**BEFORE
THE OHIO POWER SITING BOARD**

In the Matter of the Application of	)	
Kingwood Solar I LLC for a Certificate	)	Case No. 21-0117-EL-BGN
of Environmental Compatibility and	)	
Public Need	)

**KINGWOOD SOLAR'S JUNE 1, 2021 RESPONSES
TO STAFF'S MAY 17 AND MAY 20 DATA REQUESTS**

Updated Figure 03-3
Project Layout

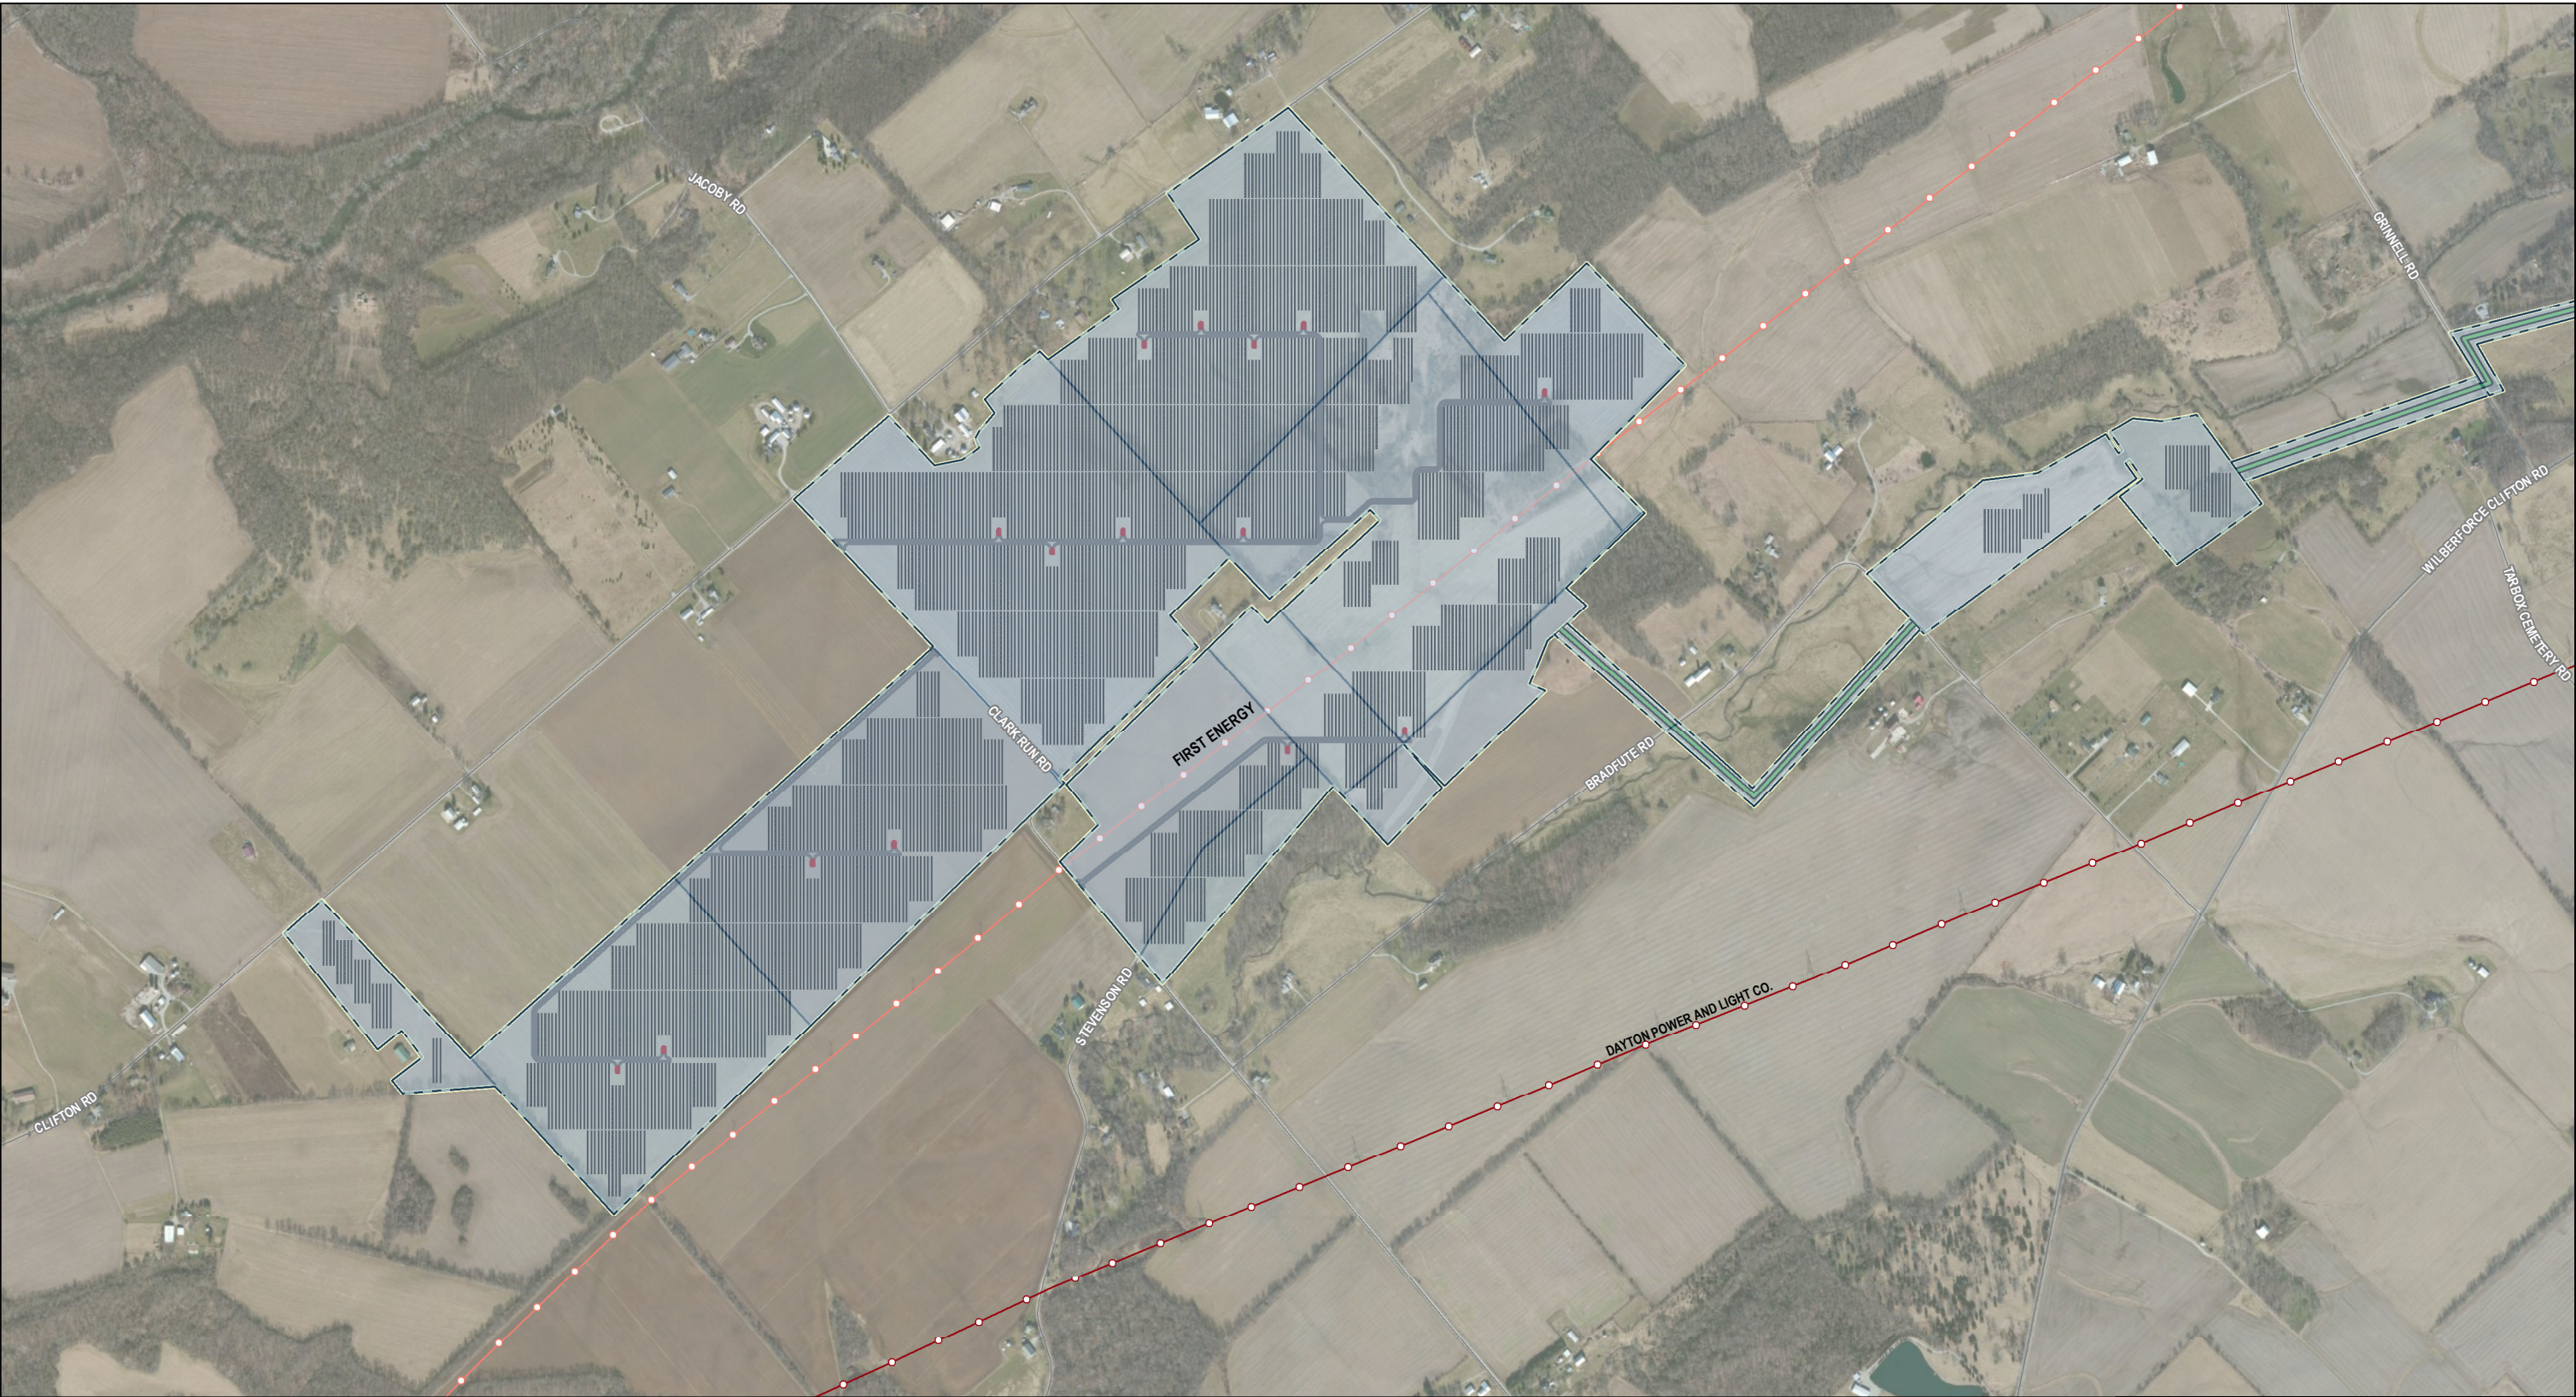
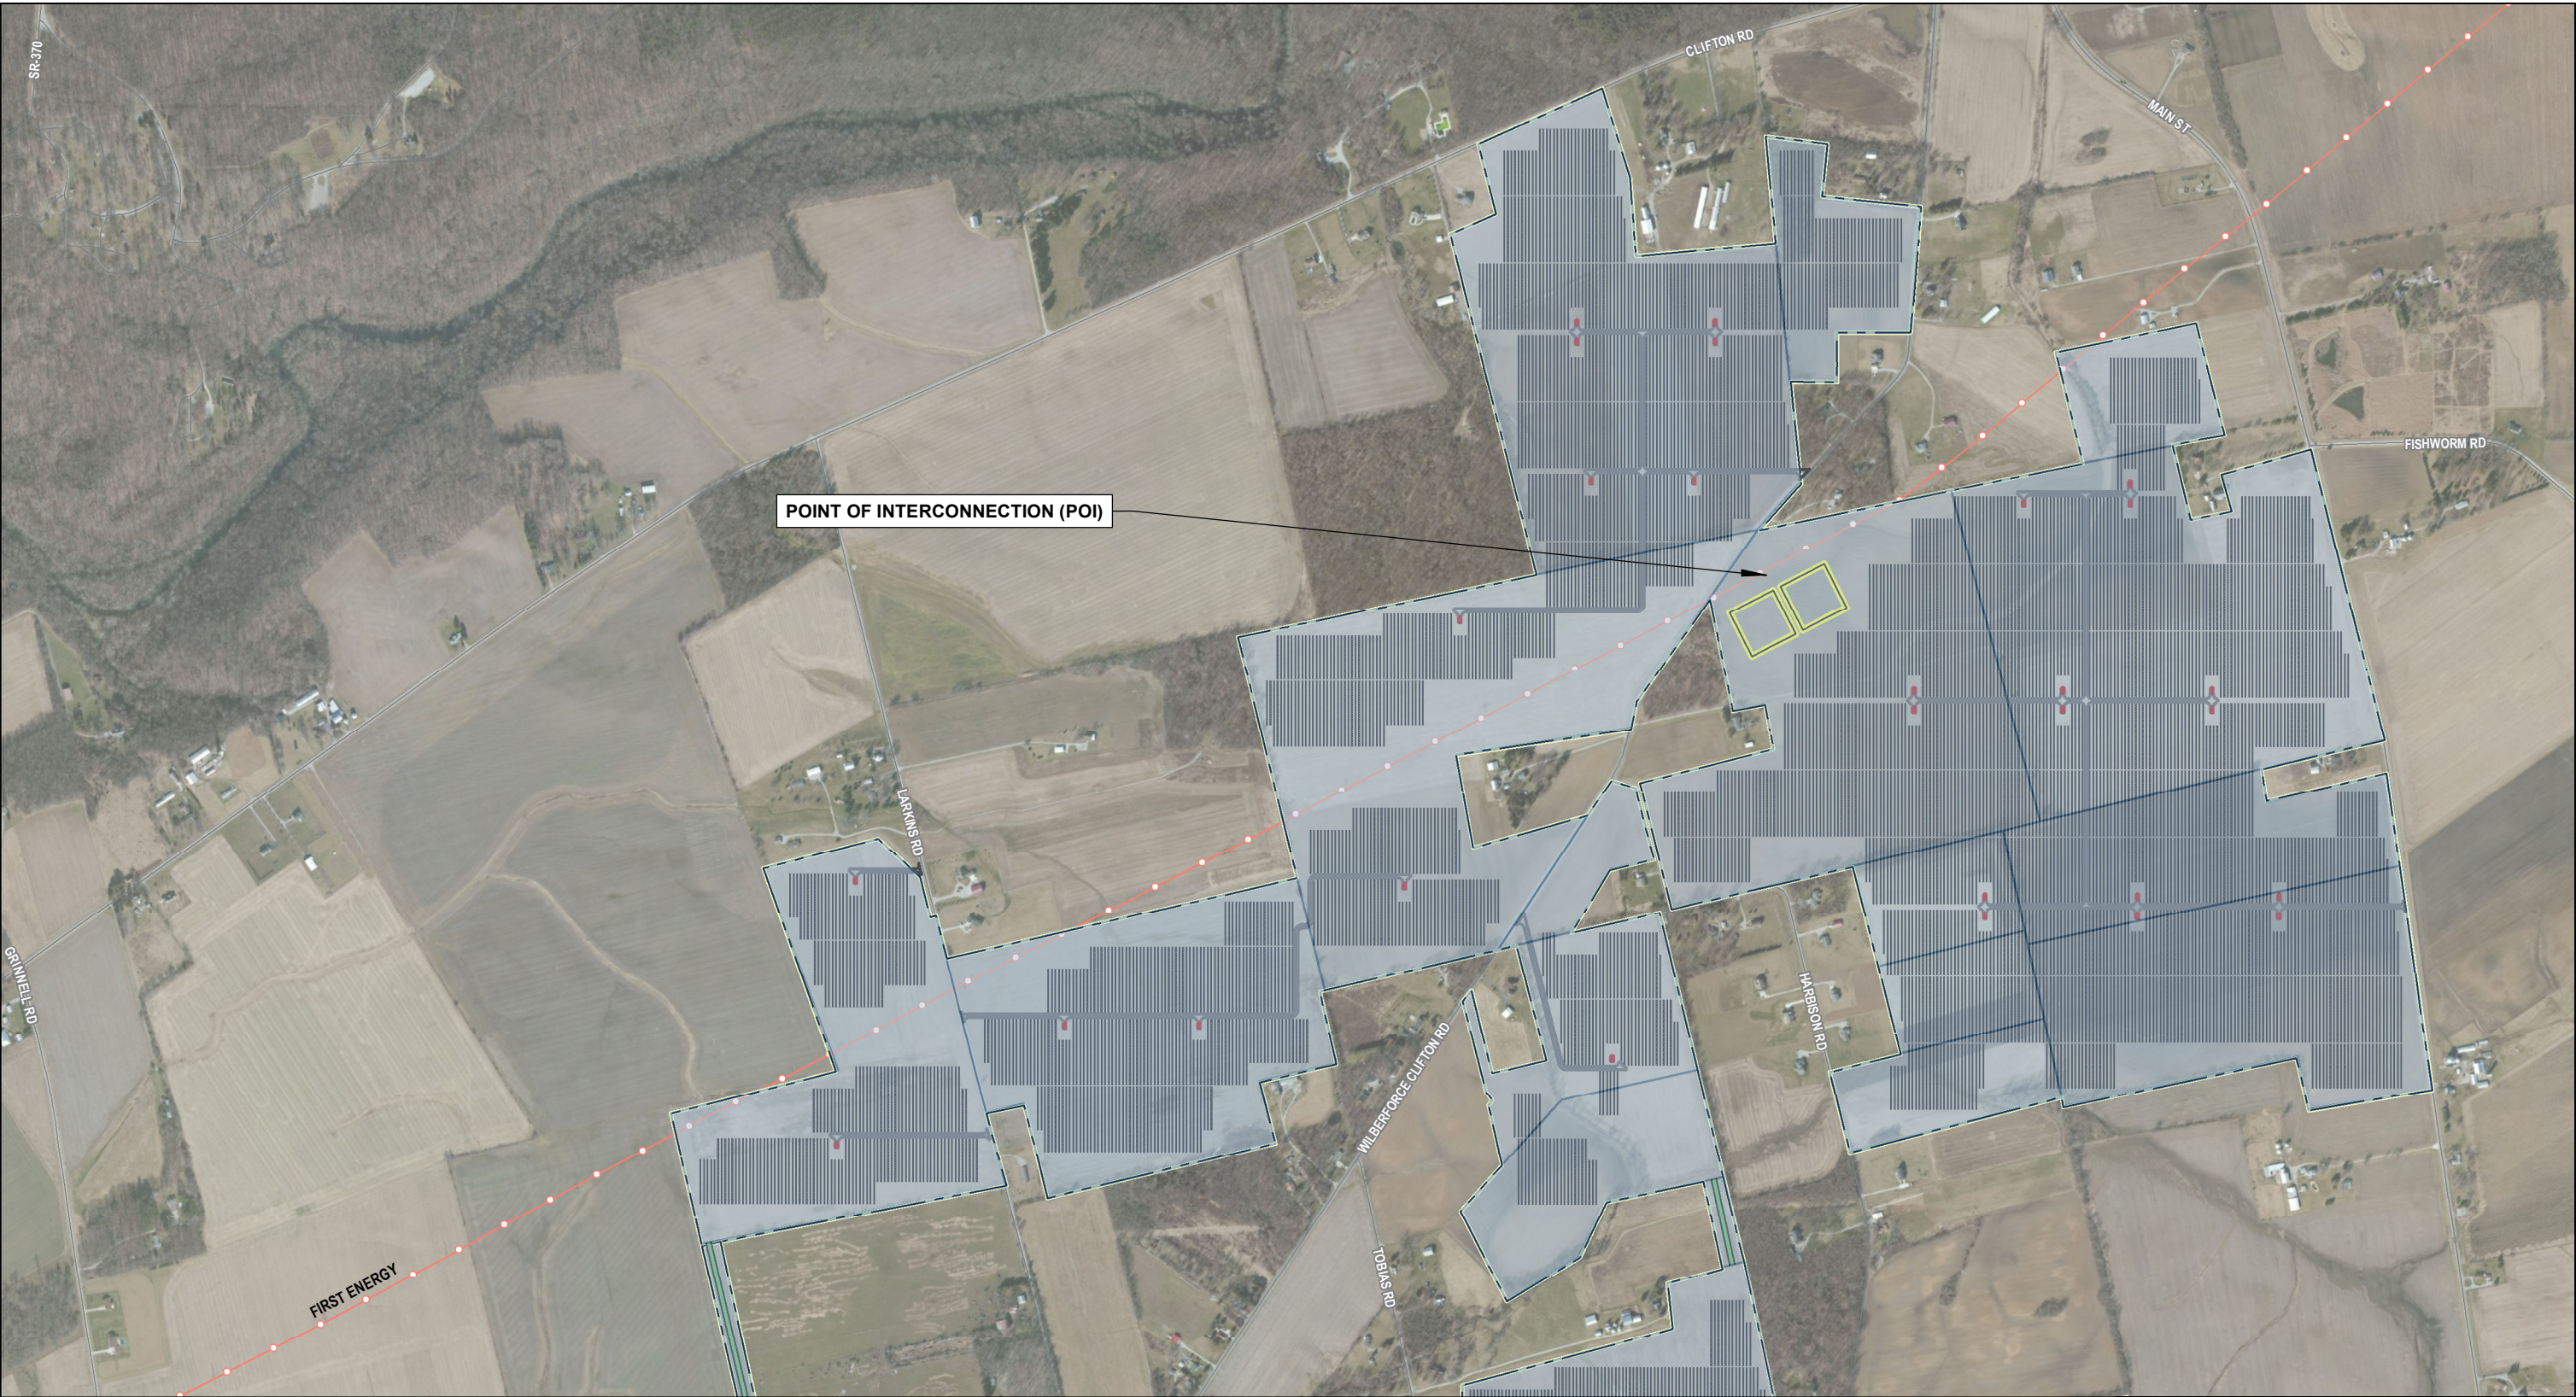
- 20. Please update Figure 03-3 (Project Layout) and other relevant facility mapping to reflect the proposed location of the gen-tie line referenced on page 1 of the Application and provide associated shapefiles.**

An updated Figure 03-3 is attached. The associated shapefiles will be provided separately to OPSB Staff.

No, the nearest residence currently measures more than 400 feet from the gen-tie line as shown in the updated Figure 03-3.
